SEWAGE DISPOSAL SYSTEM

DEPARTMENT OF HEALTH AND MENTAL HYGIENE

SUBDIVISION Foxport Plantation LOT 5 ROAD 15525 Bushy Park Road

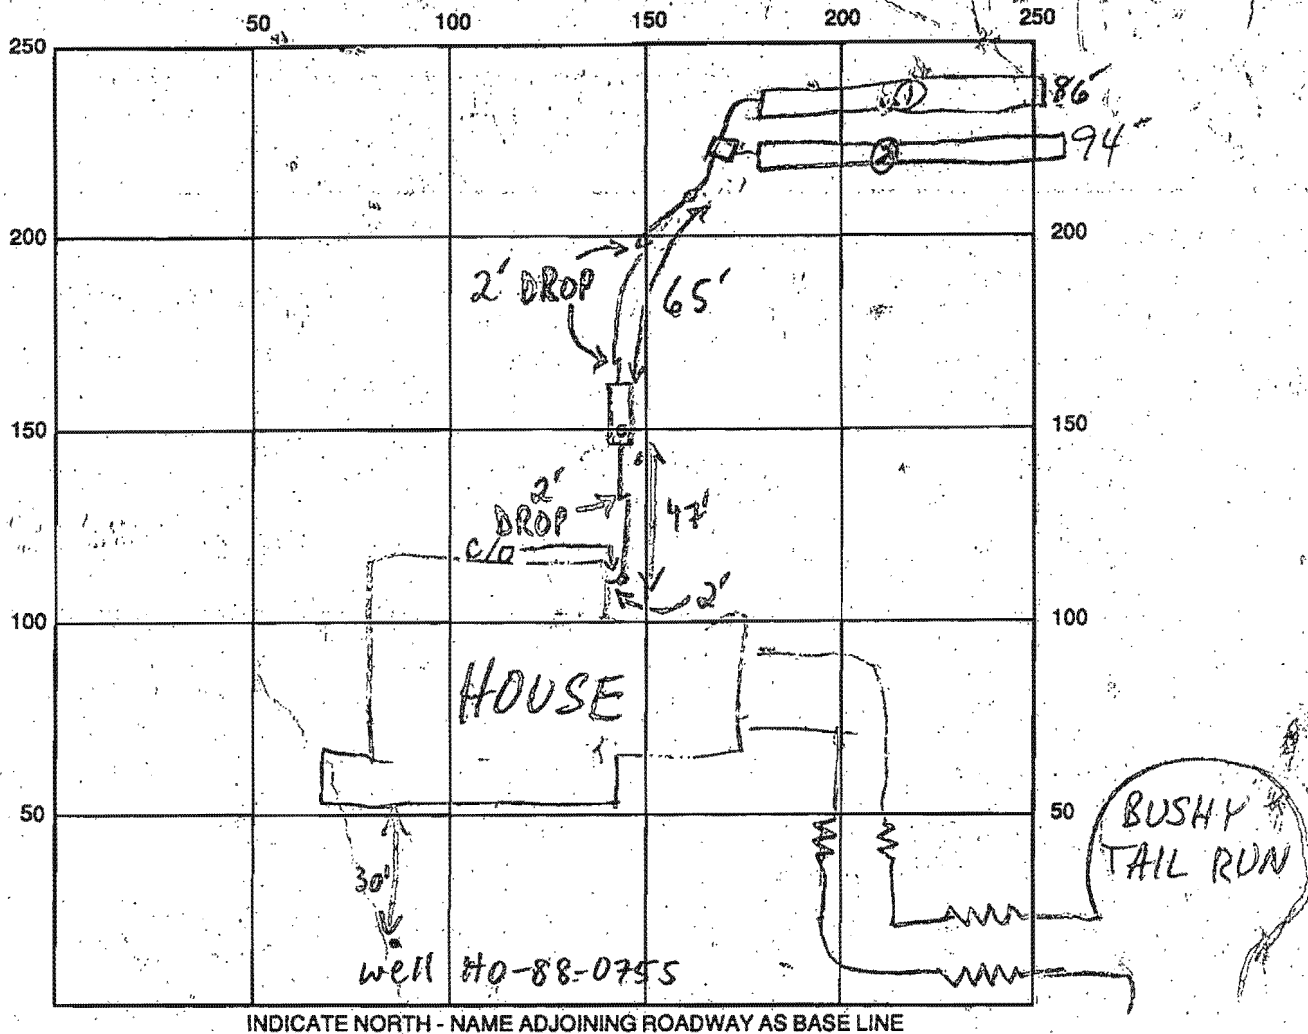
REMARKS: 2/6/91 OK TO COVER HOUSE TO END OF PIPE MR
2/8/91 OK TO STONE TRENCH @ & DIG (2); INSTALL C/O
AT 65' FROM S.T. MR 2/11/91 TRENCH @ UP TO 30-50% RX, MUCH MORE
THAN PERC NOTES INDICATE, W/SOME VERY LARGE FRAGS; TOLD
INSTALLER TO CALL IF FUTURE DEEP SYSTEMS ARE AS ROCKY,
IT INSTALLER CONT W/JOB PER EX. SPECS, (2' SHALLOWER WOULD NOT
MAKE MUCH DIFF.)

2/11/91 #2 OK TO COVER
ALL
